REV C 11/24/2015
REV B 10/24/2015
REV A 10/9/2015
DRAFT 3/25/2015

5-PIN EXPANDER BOARD			
Rev	Document Number	Rev	Doc
1	000	1	000

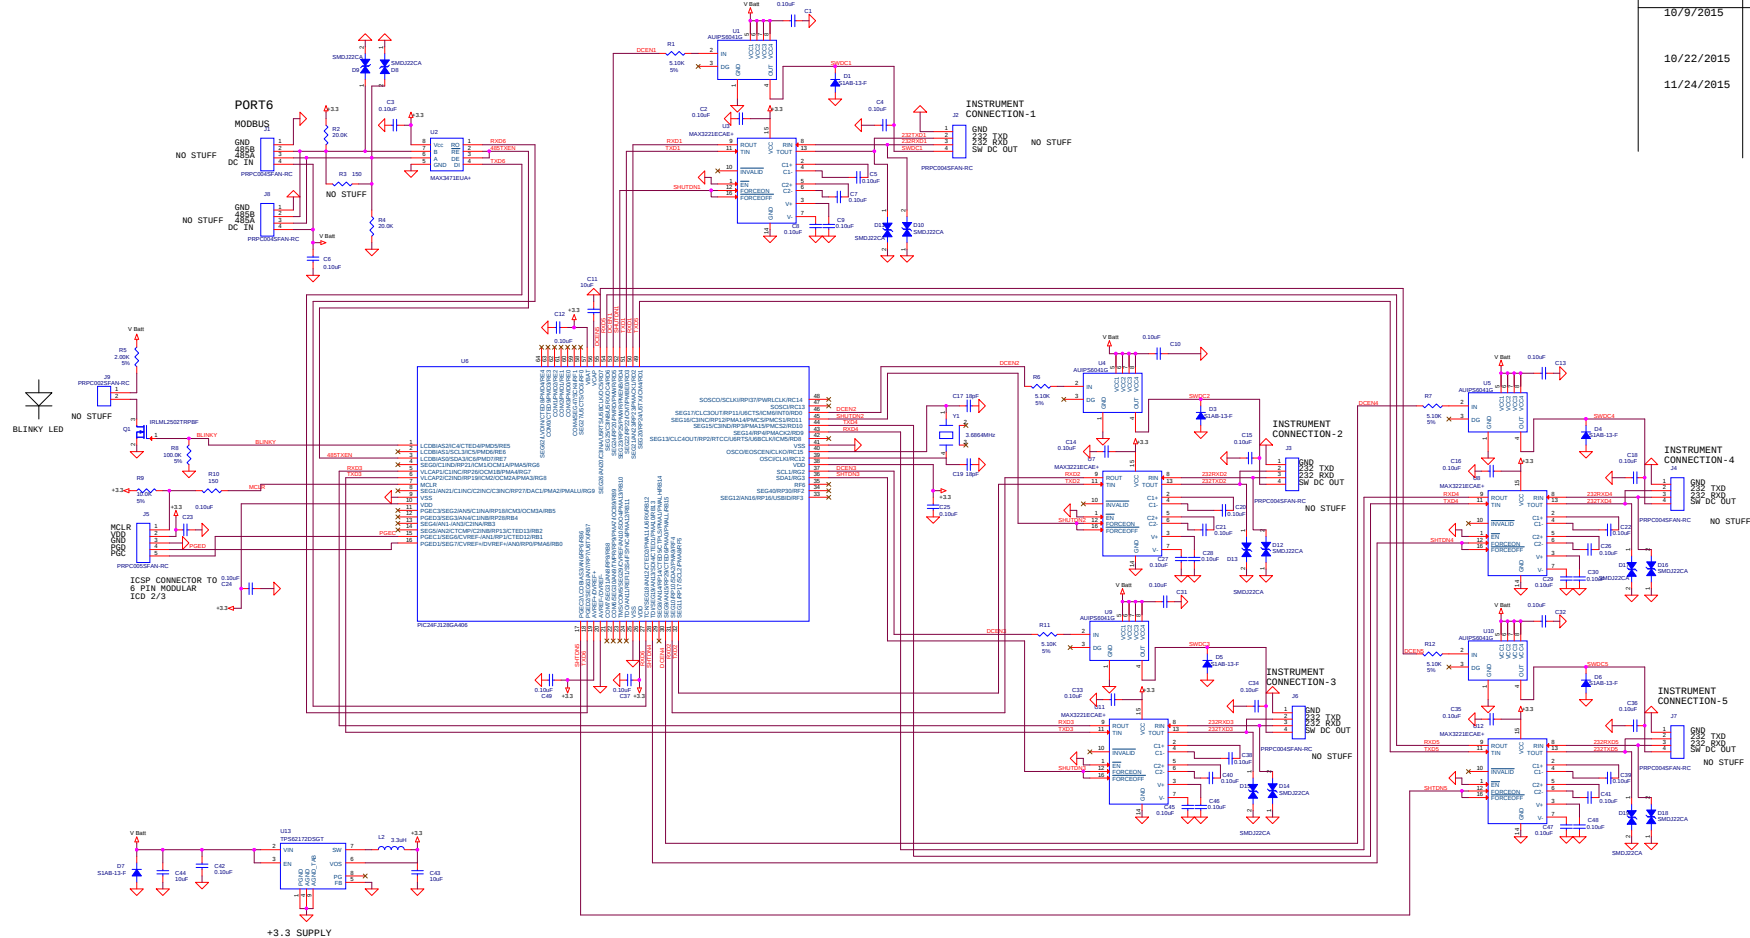
tie VUSB AND AVDD TO 3.3, add C49 at AVDD
change to PIC32MX575F256H-801/PT
REMOVE LED, ADD J9 FOR EXTERNAL LED
CHANGE TO pic24

move 48,49 to 46/47
